Preliminary Findings from Review

of the USGS Study of the
Cuyama Valley Groundwater Basin

Cuyama Basin Water District

27 October 2017 | EKI B70069.00

Figure 7

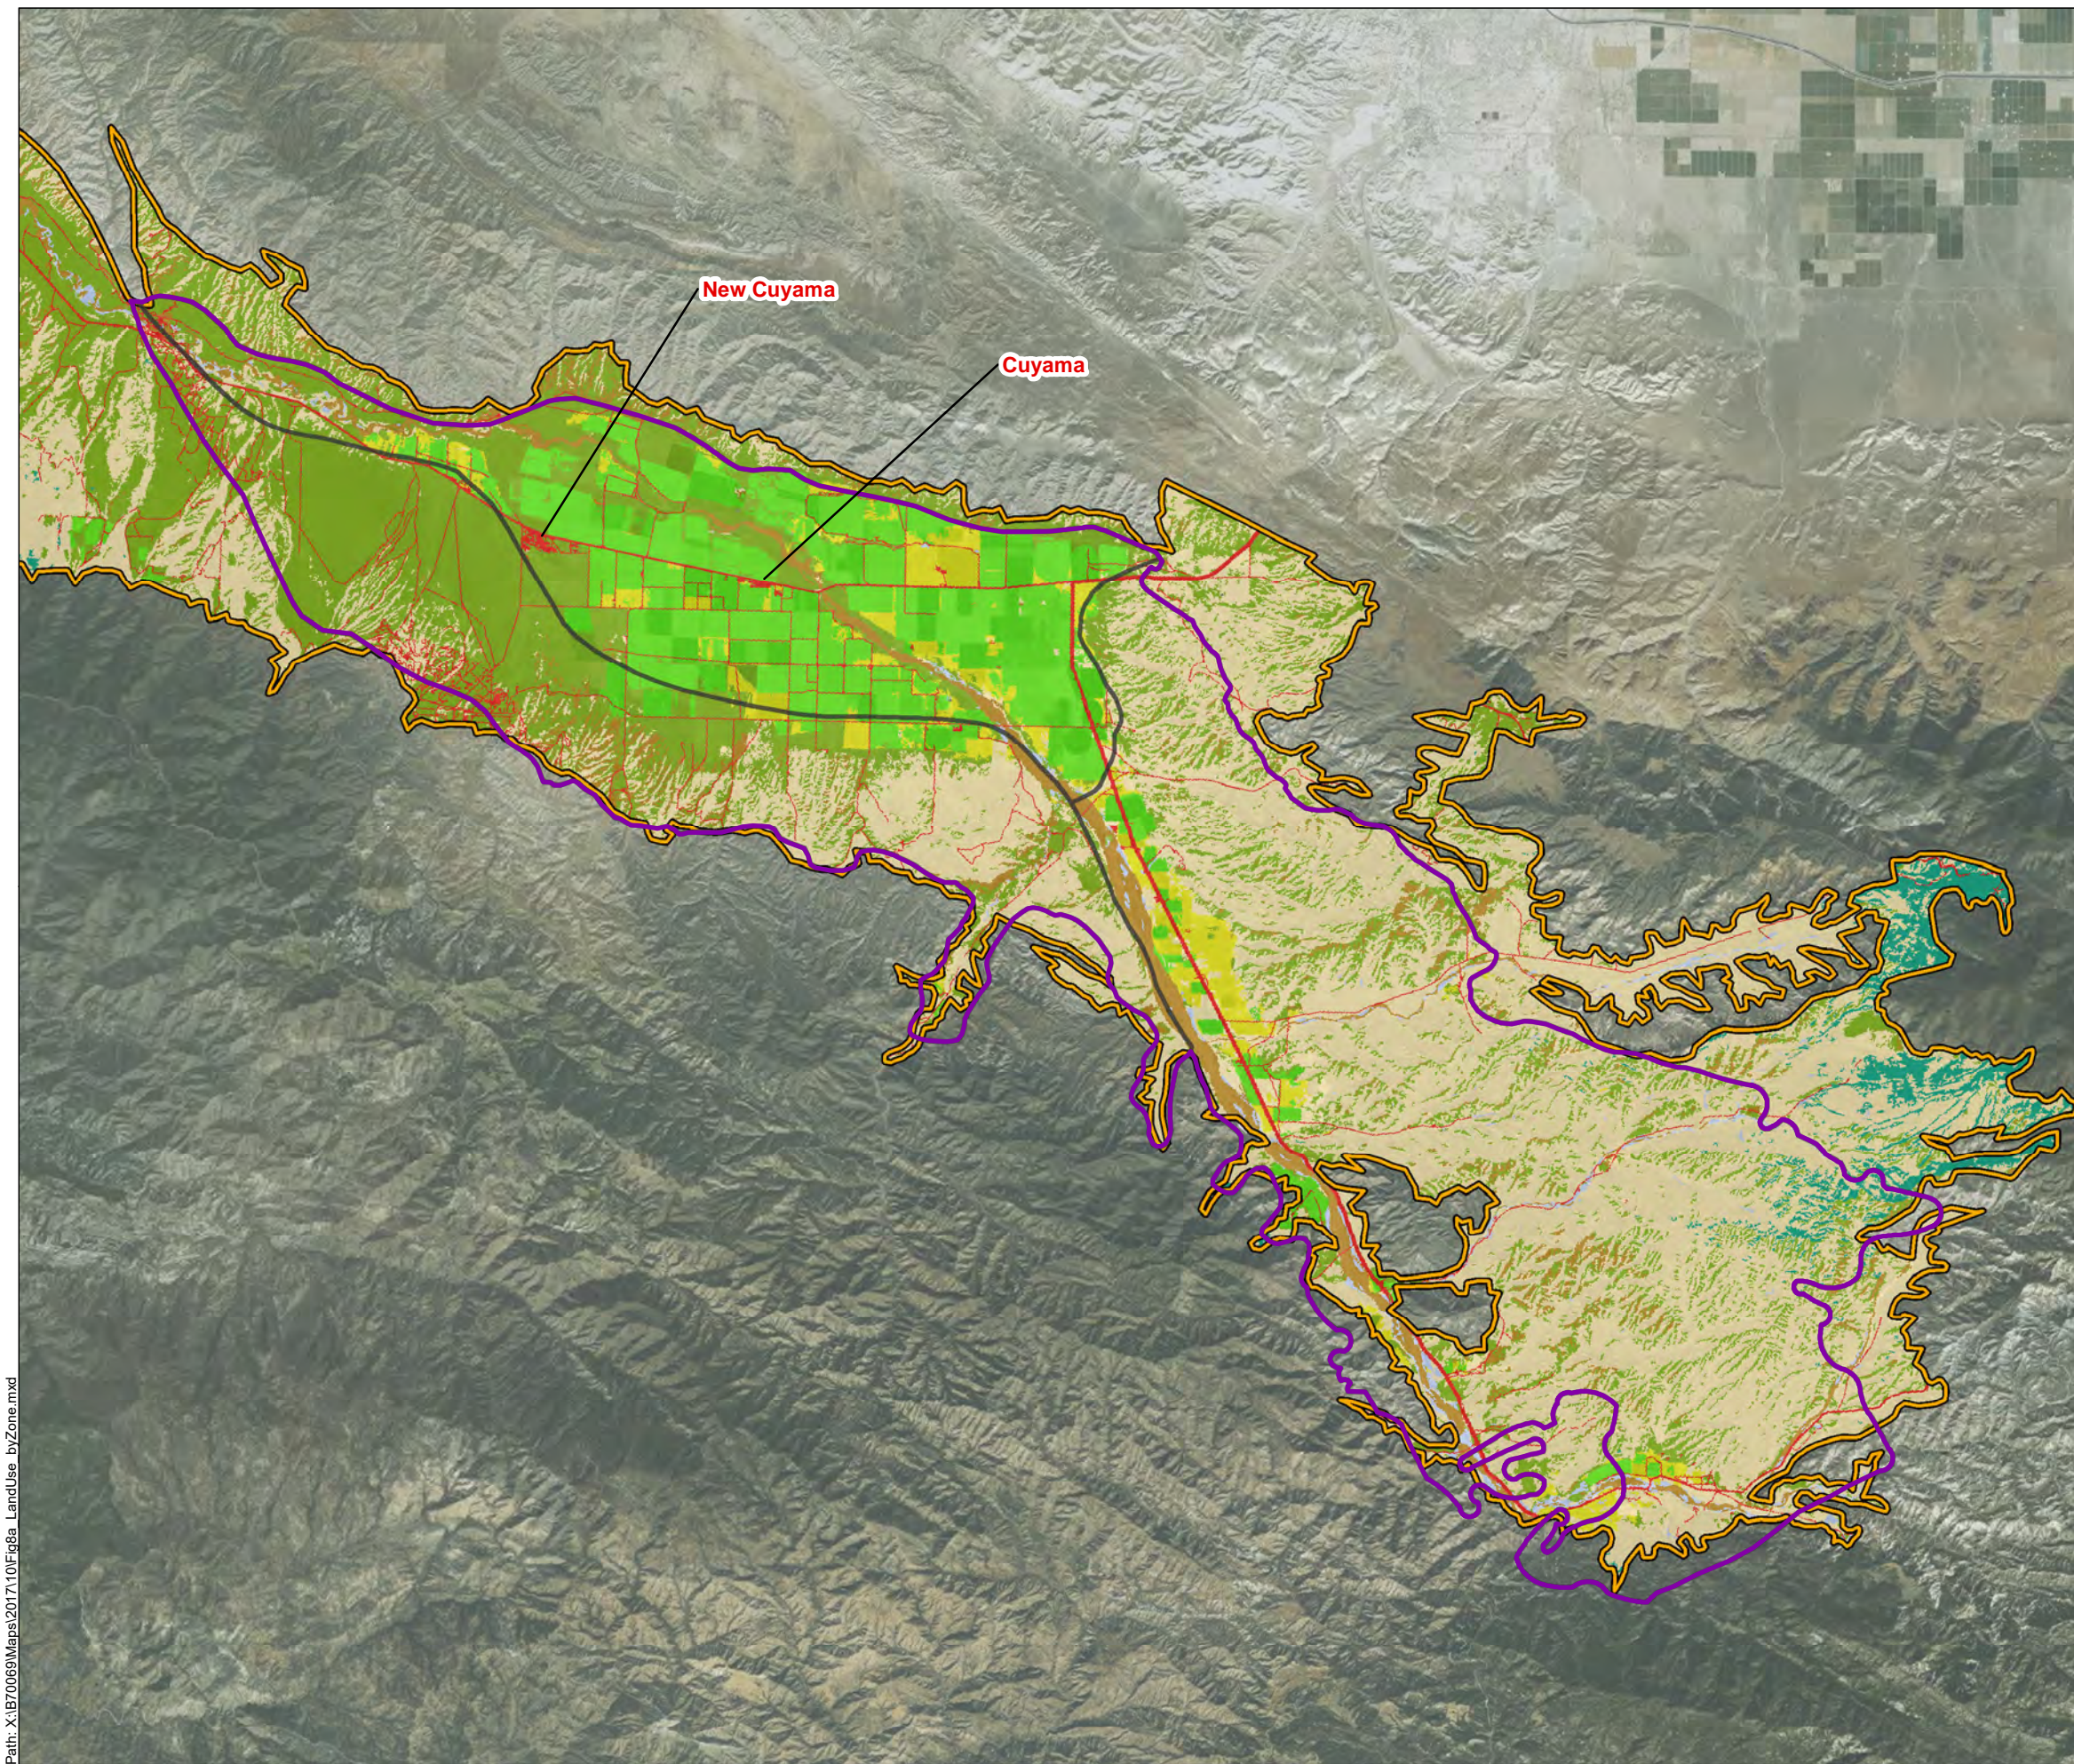
As mentioned above, the CUVHM Area covers an even more limited extent of the Cuyama Basin than does the USGS Study Area (i.e., only 44%; see Figure 7). Specifically, the CUVHM Area does not include the southern portion of the “Southern Ventucopa Uplands” subregion as defined by the USGS Study Area (shown on Figure 6), and excludes the (likely) irrigated lands within Lockwood Canyon near the southwestern Cuyama Basin boundary. Additionally, the western boundary of the CUVHM Area does not trace the mapped trace of the Russell fault as it does in the USGS Study Area. Furthermore, the BCM Area used to derive precipitation-runoff relationships and estimate recharge to the Cuyama Basin only accounts for 41 of the 58 watersheds¹³ contributing to basin recharge (see Figure 7).

Figure 8a

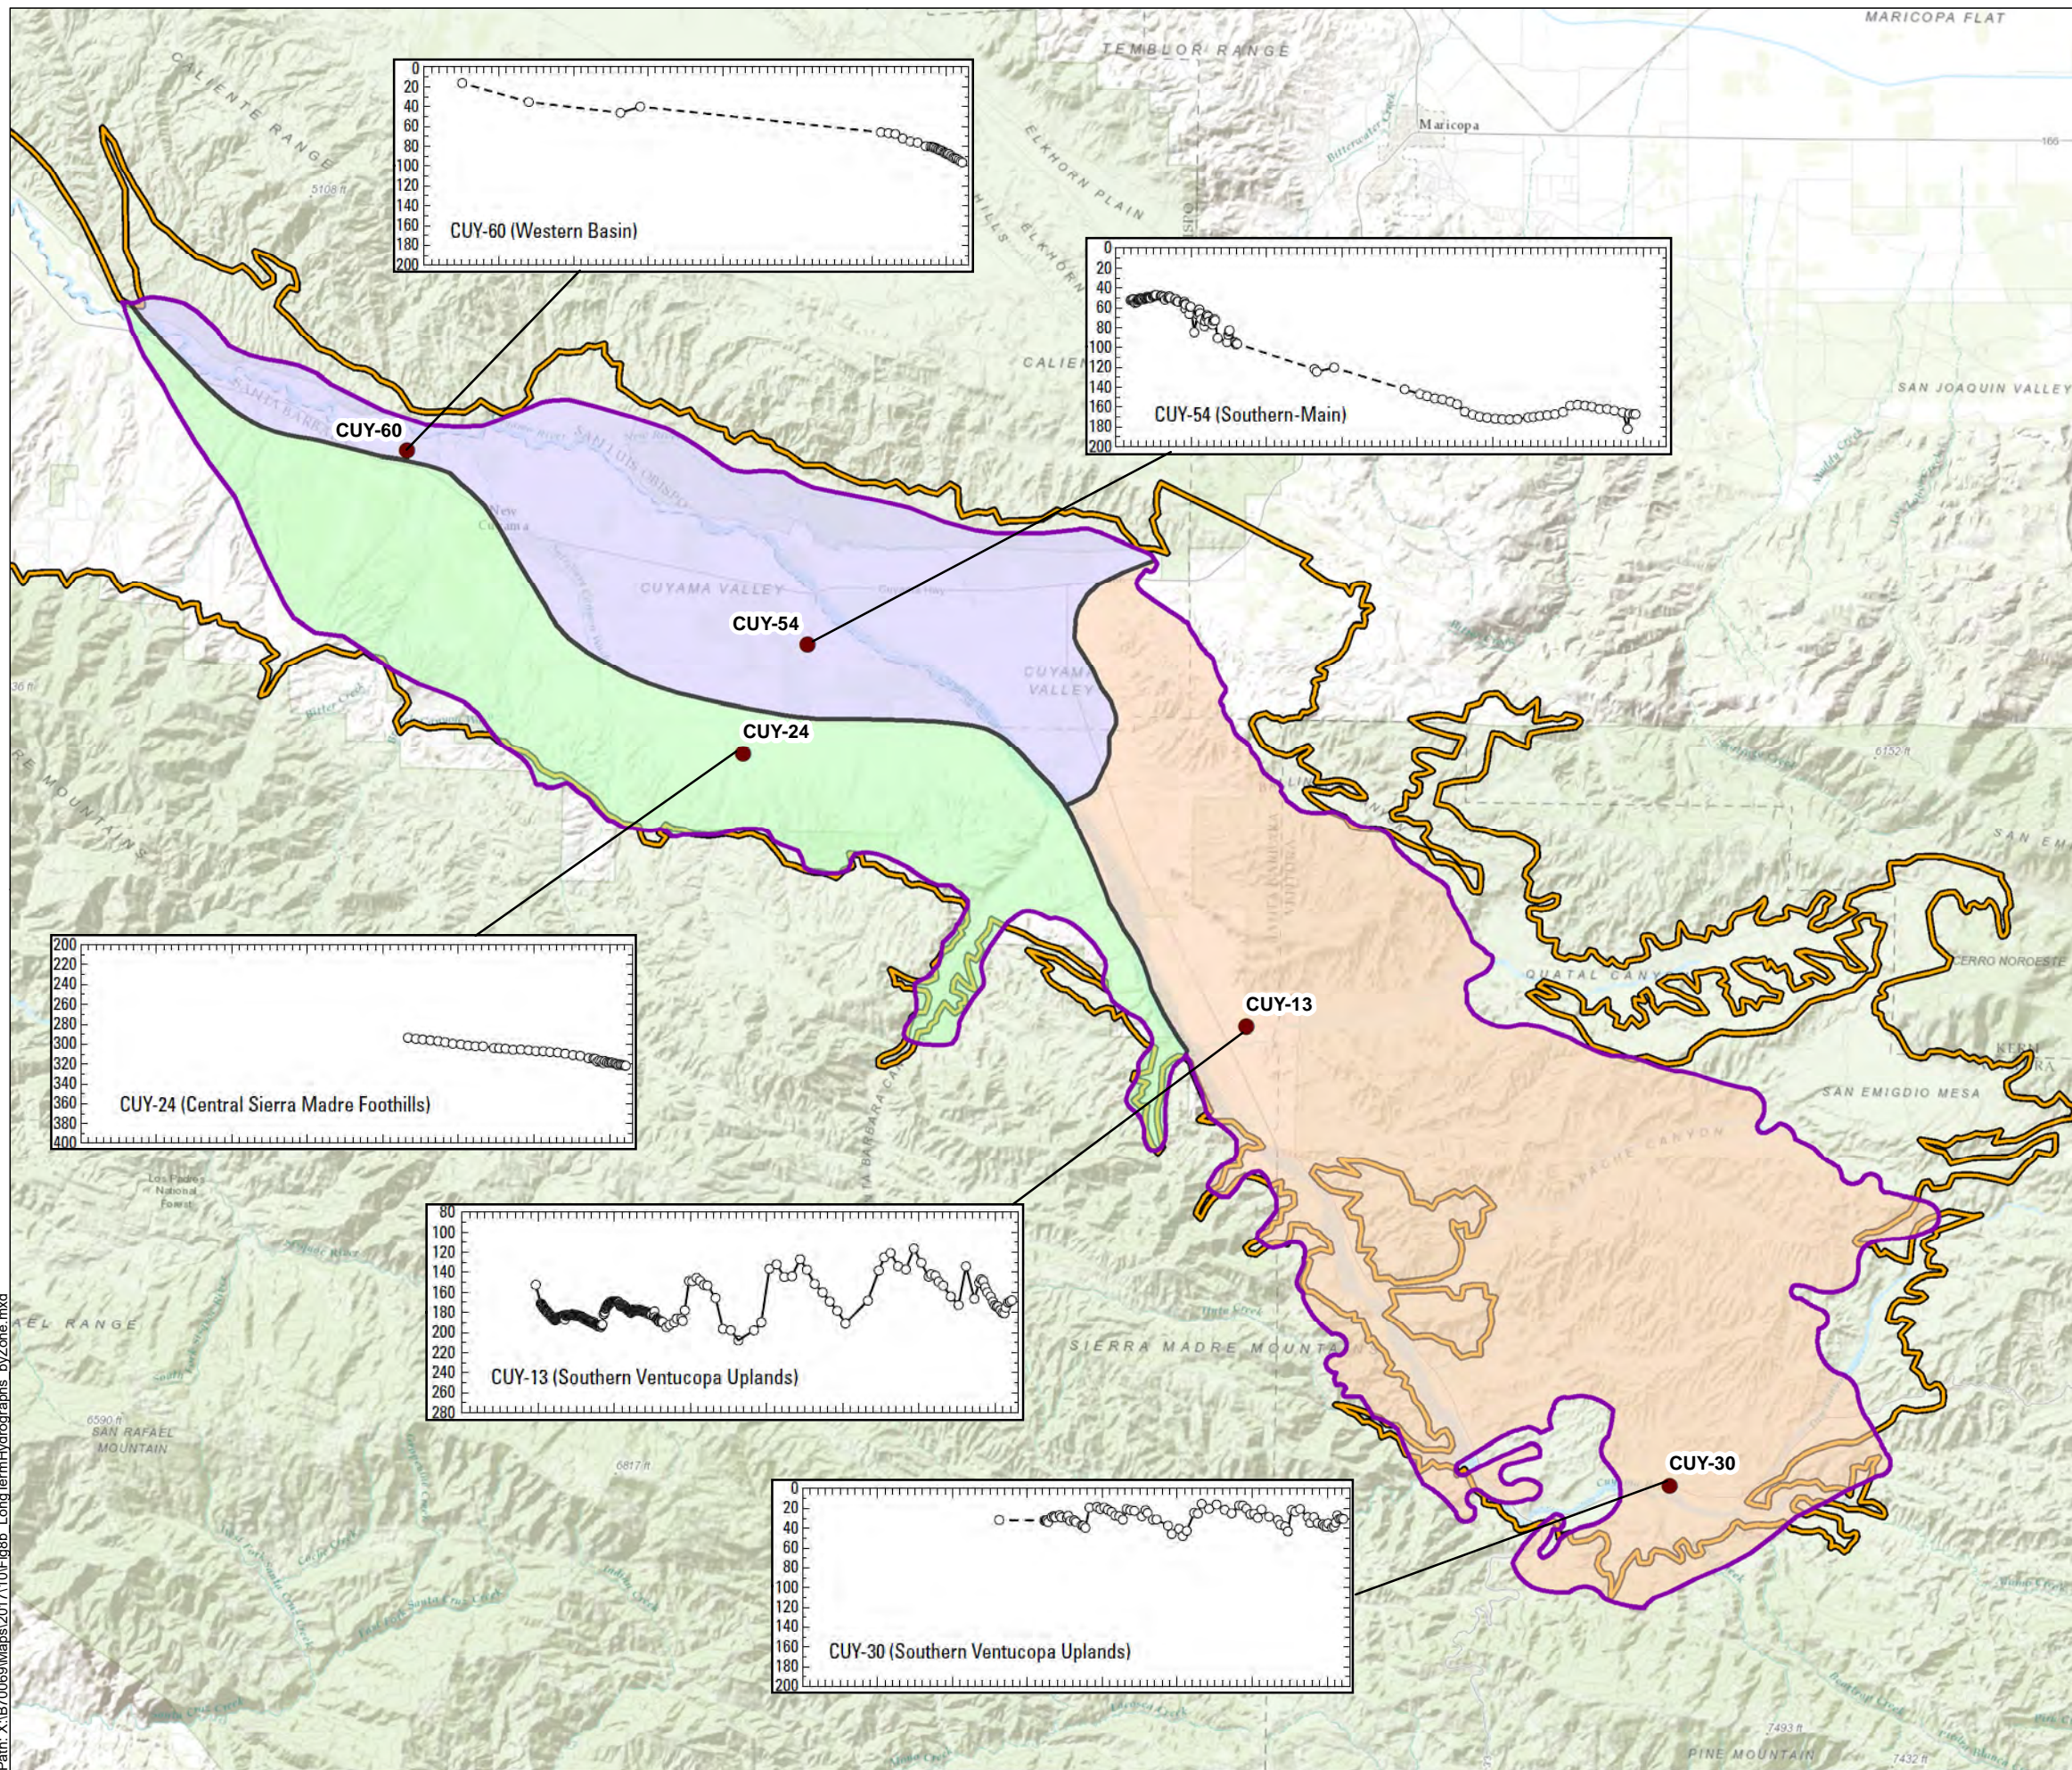
Based on the inspection of land use information (see Figure 8a), it appears that the “zone” boundaries put forth by the USGS largely coincide with land use patterns. As shown on Figure 8a, the Main zone is dominated by irrigated crops, the Sierra Madre Foothills zone is dominated by grassland/herbaceous and shrub/scrub land cover, and the Ventucopa Uplands zone is
